DESIGN REVIEW COMMITTEE

December 17, 2025 6:00 PM

DATE: December 12, 2025
TO: Tonya Hutson
FROM: Lynn Patterson
RE: **Design Review – 3335 Dogwood Drive Revision**

DEPARTMENT OF PLANNING AND ZONING
PLANNER'S REPORT

Lot # 9 – Building 1000

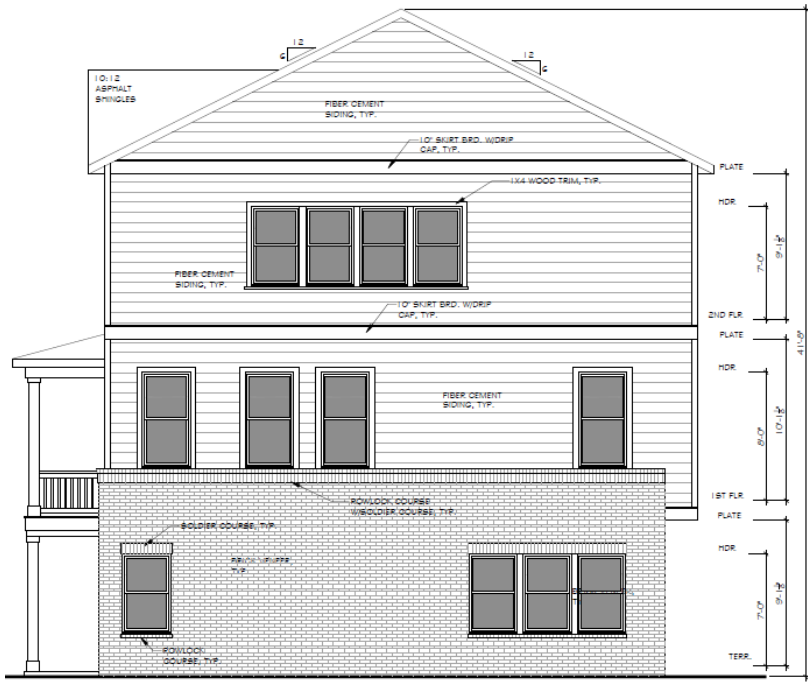
The City of Hapeville had received revisions for the townhomes at 3335 Dogwood Drive to modify the exterior facades. The requested modification is to reverse/mirror the window configuration for Unit 9 Building 1000, Unit 18 Building 3000, Unit 25 Building 3000, Unit 26 Building 4000, and Unit 32 Building 4000. A comparison of the approved plans and proposed plans are provided. The request is based upon a drafting error by the architect.

As this is a simple reversal of the window order, Staff recommends approval of the requested change.

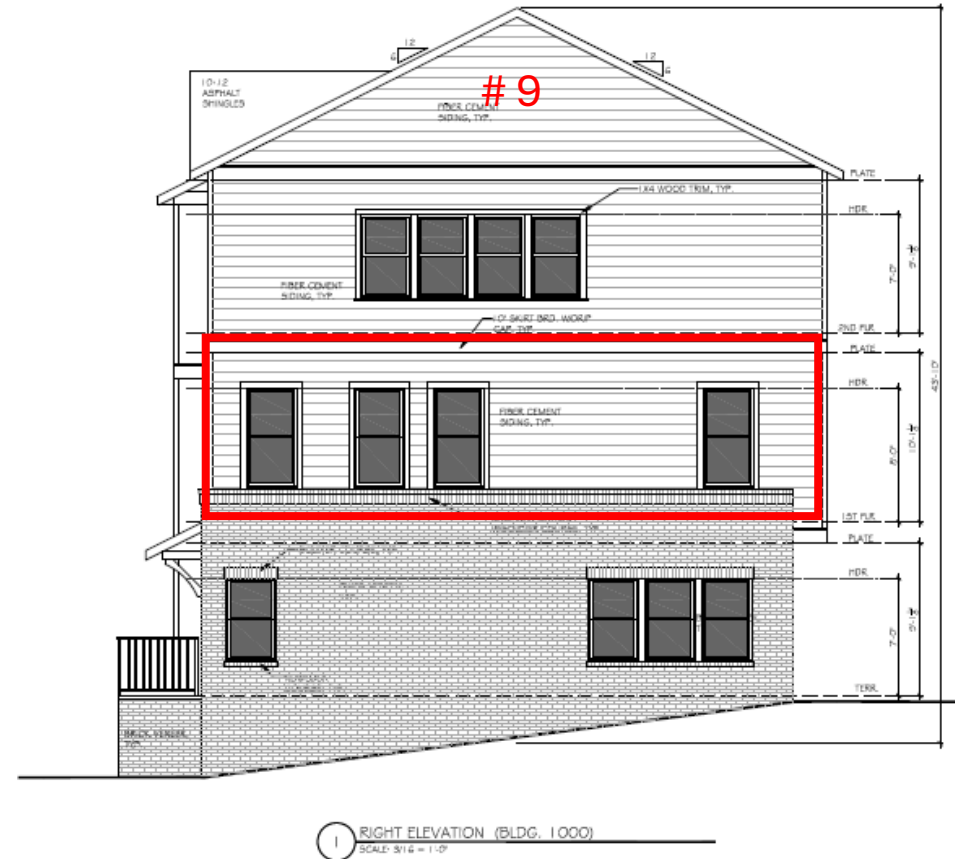
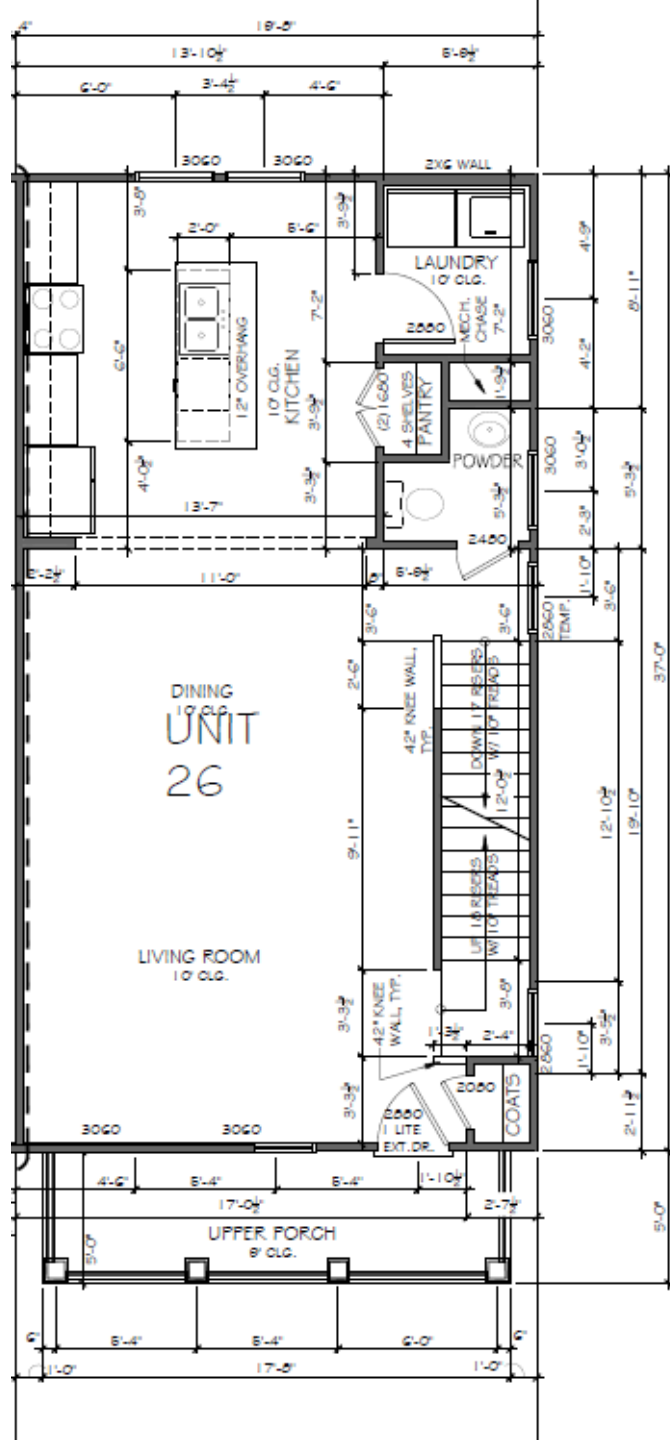
Windows on 2nd story of elevation of unit 9 in building 1000 need to be flipped/mirrored to match floorplans

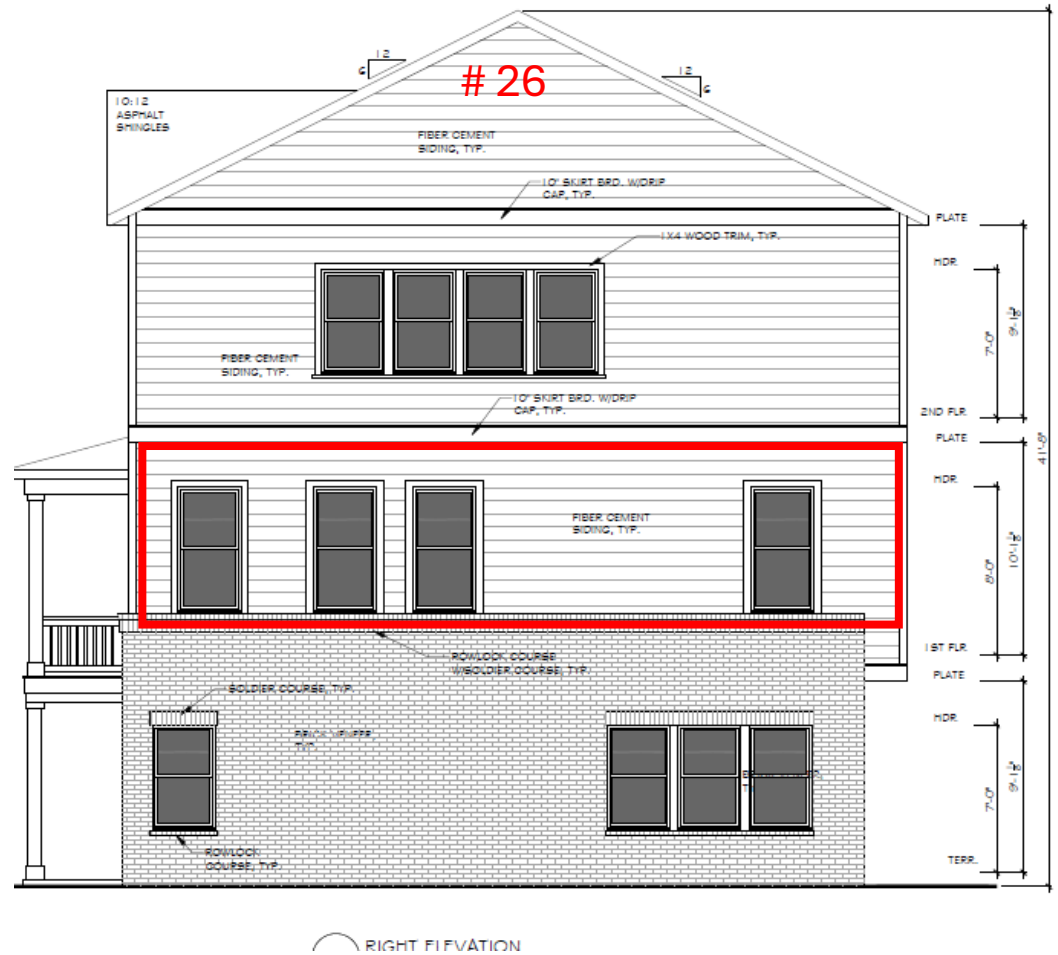
Windows on 2nd story of elevation of unit 26 in building 4000 need to be flipped/mirrored to match floorplans
